ARC REVIEW CODE: R2003241

Name of Proposal: Riverside West Business Park (DRI #3080)

RIVERSIDE WEST BUSINESS PARK DRI
City of Douglasville
Natural Resources Group Review Comments
March 24, 2020

DRI SITE PLAN

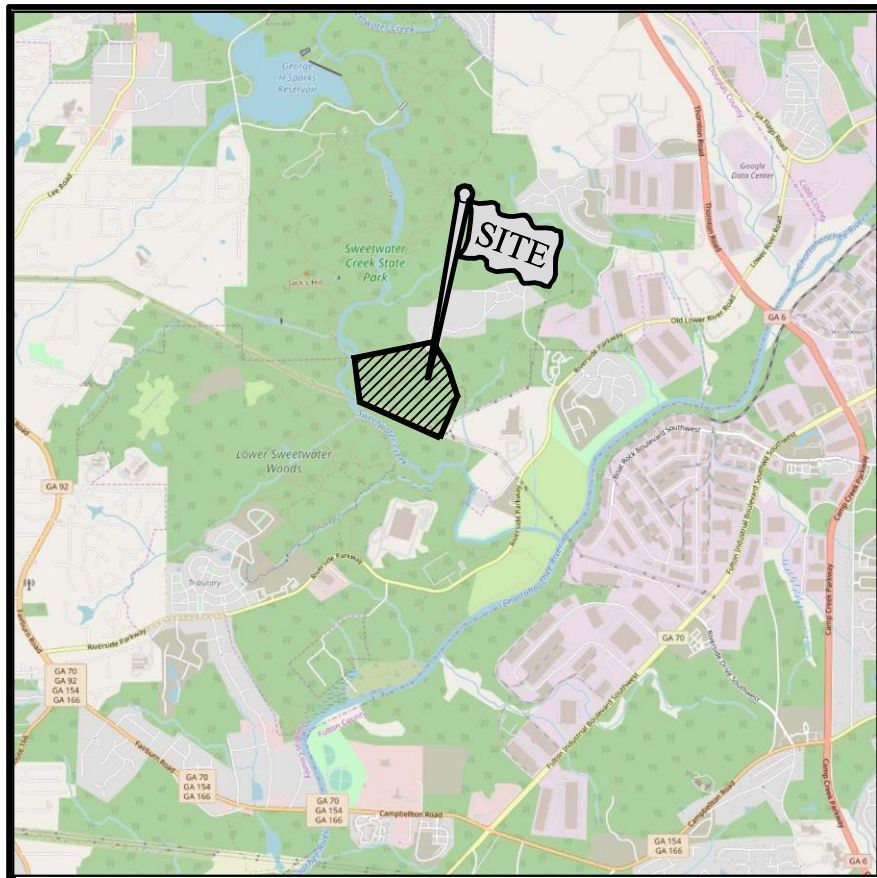
The USGS coverage for the project area shows no blue-line streams on the property. Based on the submitted site plan, the property does not extend to the banks of Sweetwater Creek, but portions of the property may be within 75 feet of the Creek. In addition, the site plan shows five unmapped streams on the property, three of which will be affected by the proposed project, with buildings, parking areas and outdoor storage built over them. No buffers are shown on any of the streams. If these streams are subject to the City's 50-foot stream buffer and additional 25-foot impervious setback, they should be shown, and any intrusions in the buffer or setback will be subject to the requirements of the City of Douglasville's Stream Buffer Ordinance. These streams, as well as any other waters of the state on the property, are also subject to the State 25-foot State Erosion and Sedimentation Act buffer, and any intrusions into those buffers may require variances. In addition, the City buffers should be shown along any portion of the property within the buffer or setback area of Sweetwater Creek.

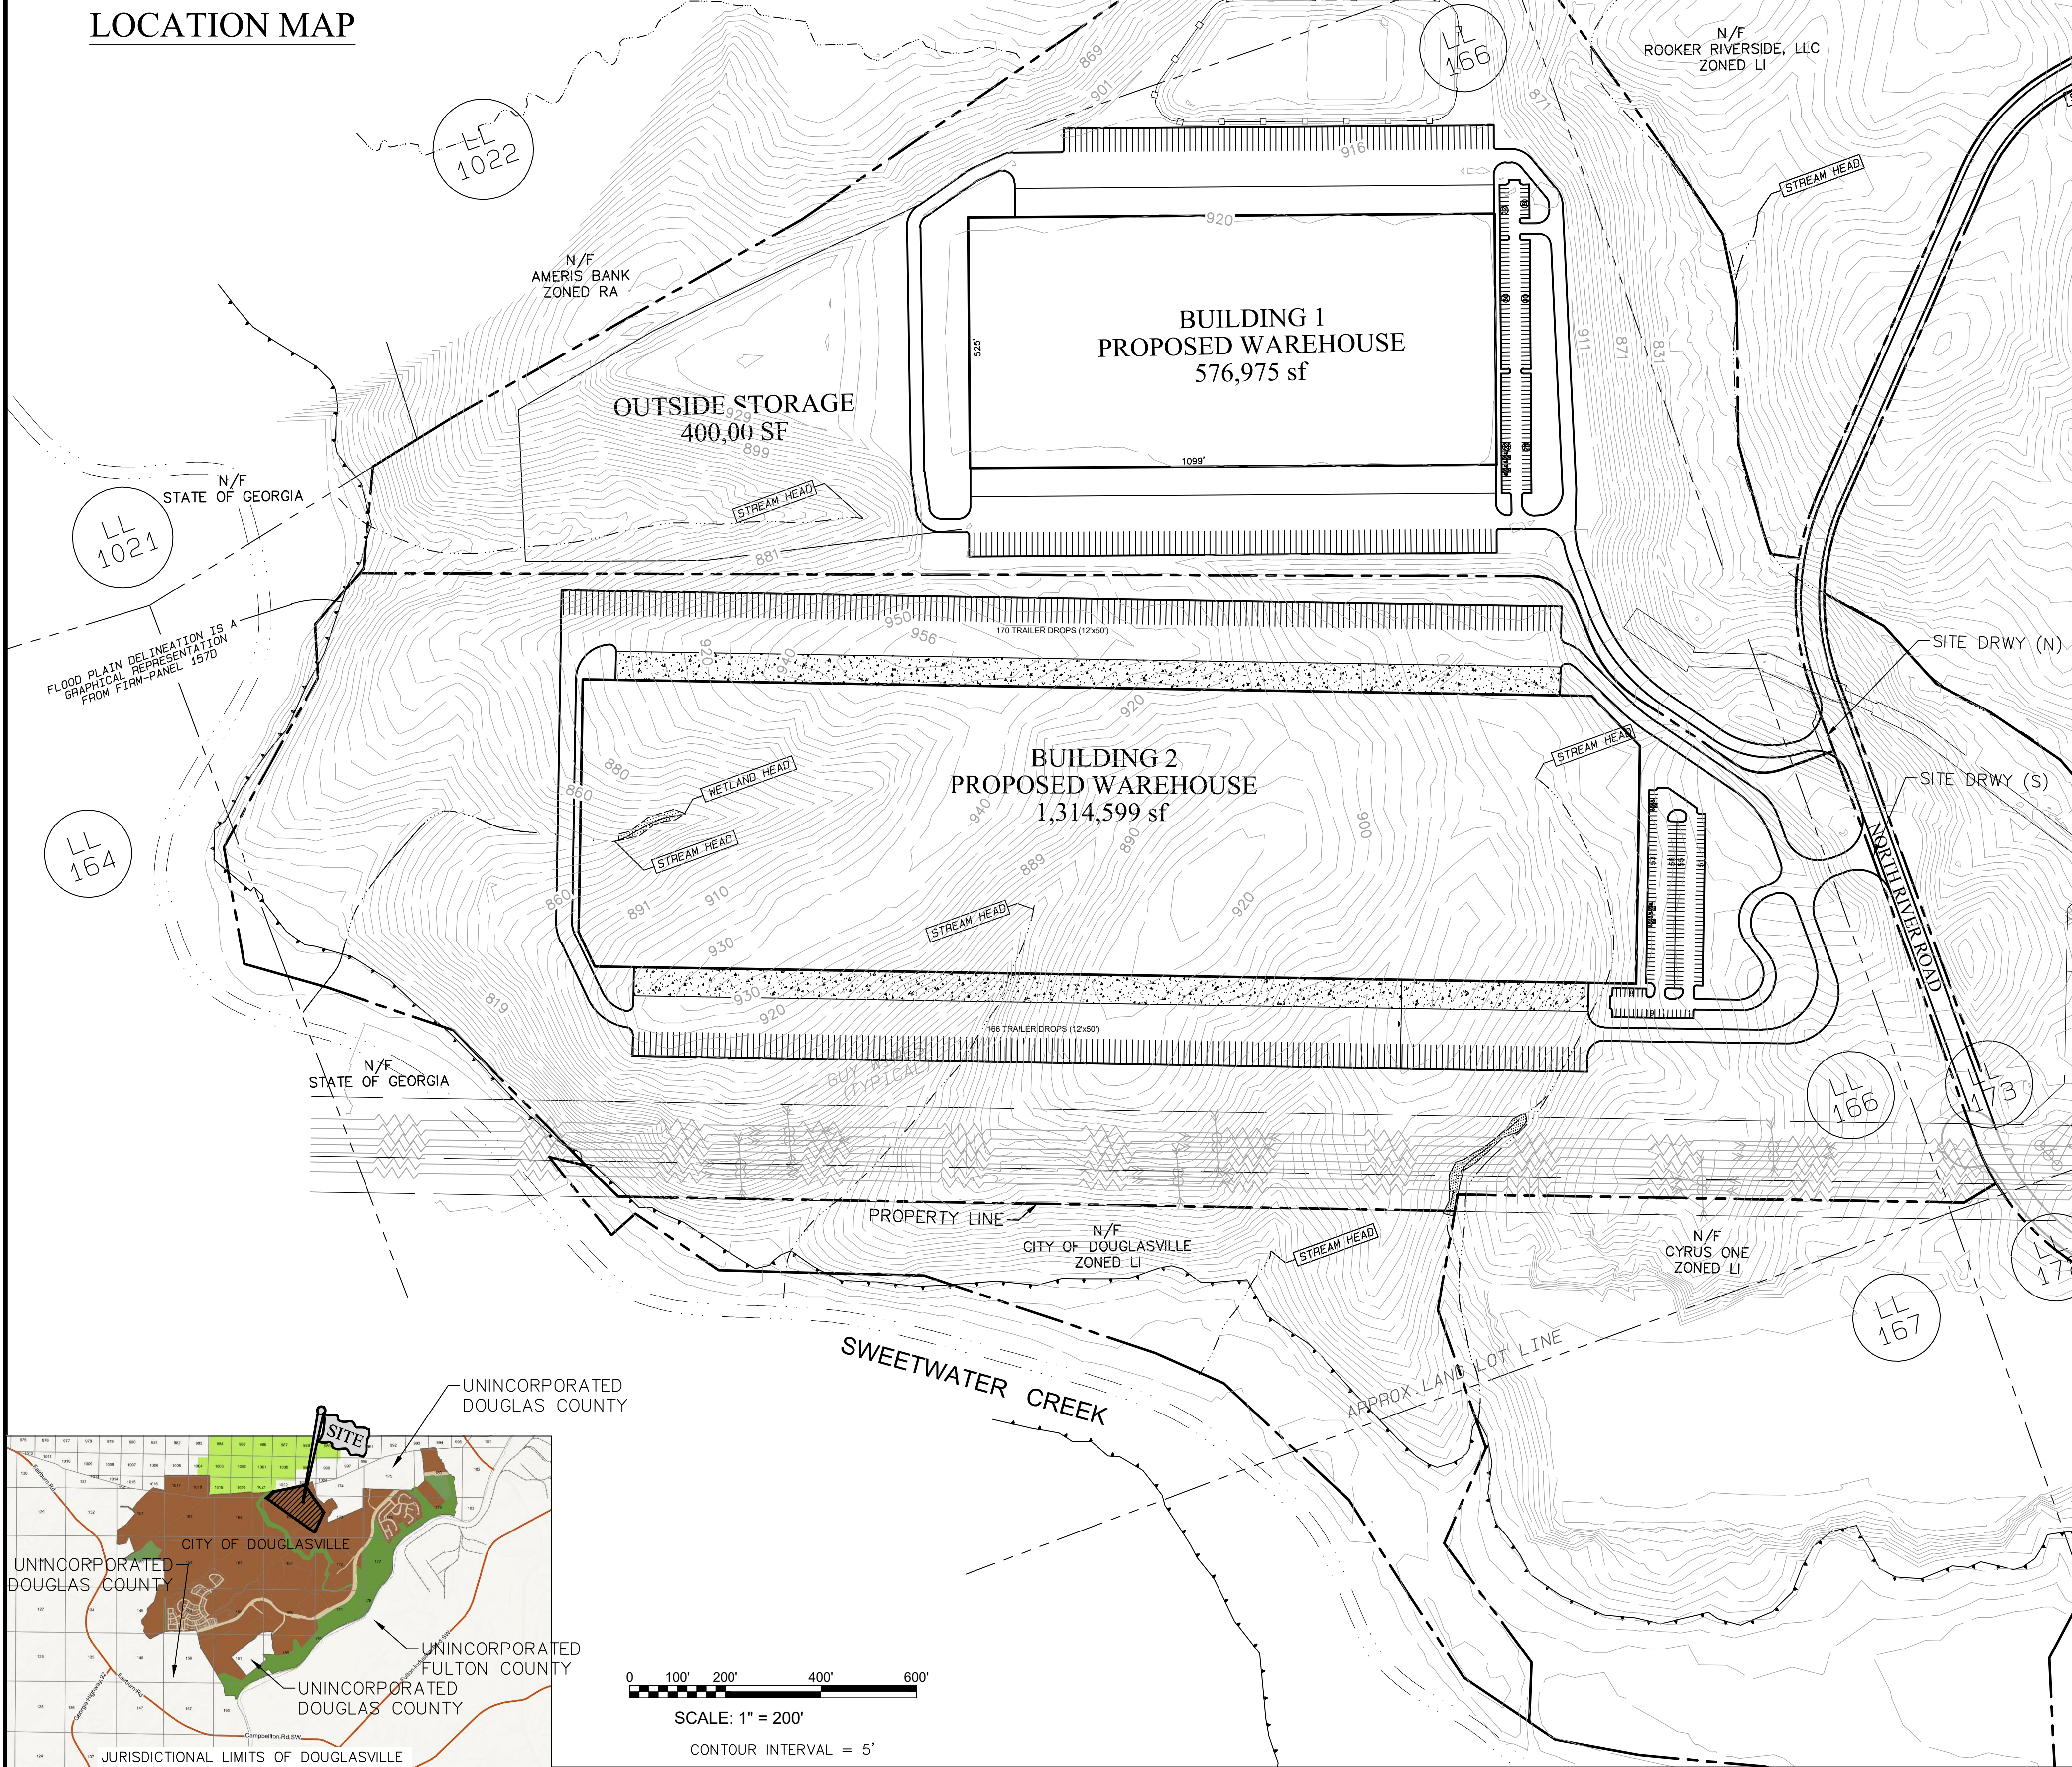
The DRI's site design should provide sufficient truck parking to prevent trucks from queuing or waiting on any adjacent or nearby roads. Trucks parking in and along public roadways – typically while waiting for an available dock at a nearby facility – is an identified issue in many areas of the region that negatively impacts roadway operations, safety and congestion. Signage and other measures to ensure drivers use the appropriate freight routes should be emphasized.
